Proposal for Supplement 11 to the 03 series of amendments and Supplement 1 to the 04 series of amendments to UN Regulation No. 129 (Enhanced Child Restraint Systems)

Submitted by the expert from France

The text reproduced below was prepared by the expert from France. The proposal aims to allow installation of a dummy protective device on the bench of UN Regulation No. 129 in the dynamic frontal test with a universal booster cushion. The modifications to the current text of the UN Regulation are marked in “(bold) blue” for new or strikethrough for deleted characters.

Figure 1

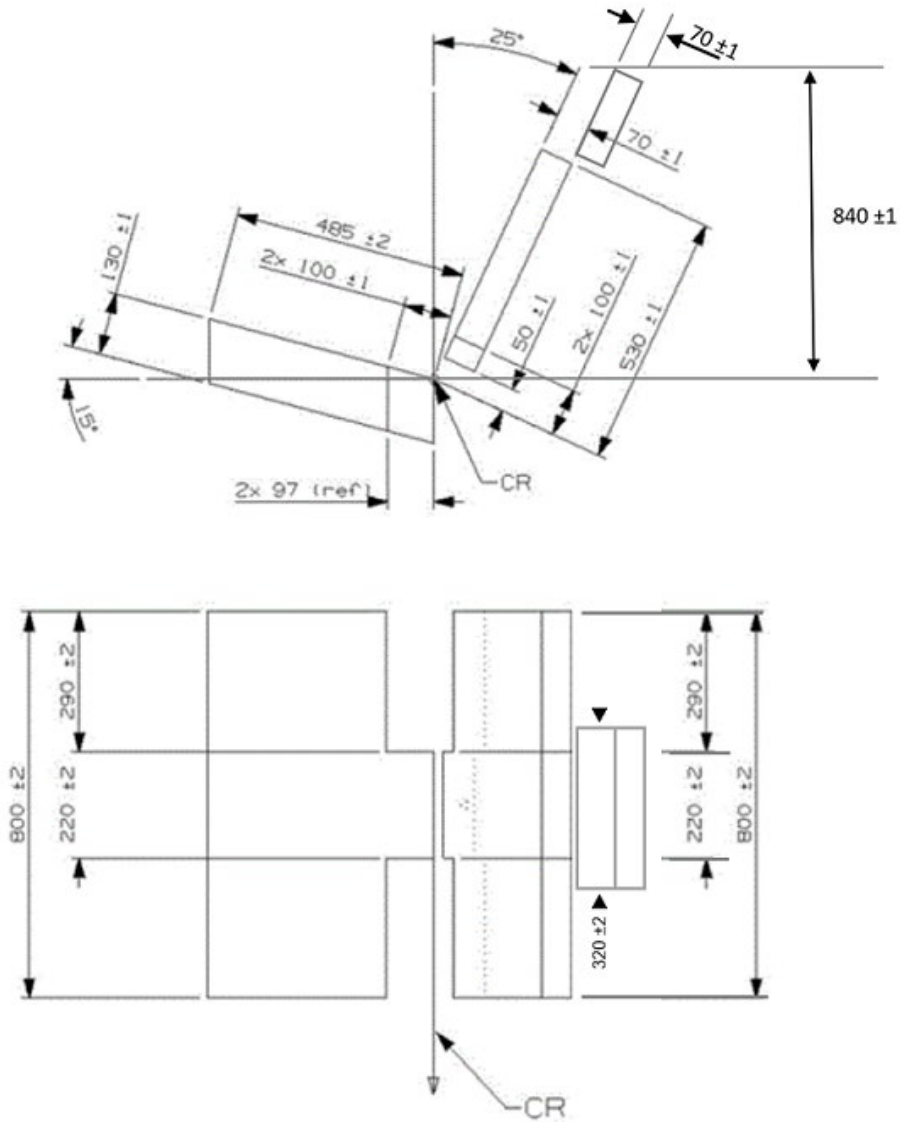
The dimensions of the dummy protective device are given in Appendix 3 of this Annex.

The forward face of the dummy protective device shall be parallel with the back of the backrest. The design of the dummy protective device shall be such that it does not interfere with the manikin when positioned on the test bench. Furthermore, the dummy protective device shall not interfere with the dummy and/or the adult 3-point belt during the dynamic test until the maximum horizontal head excursion has been reached.

" Annex 6 - Appendix 5

Optional dummy protective device
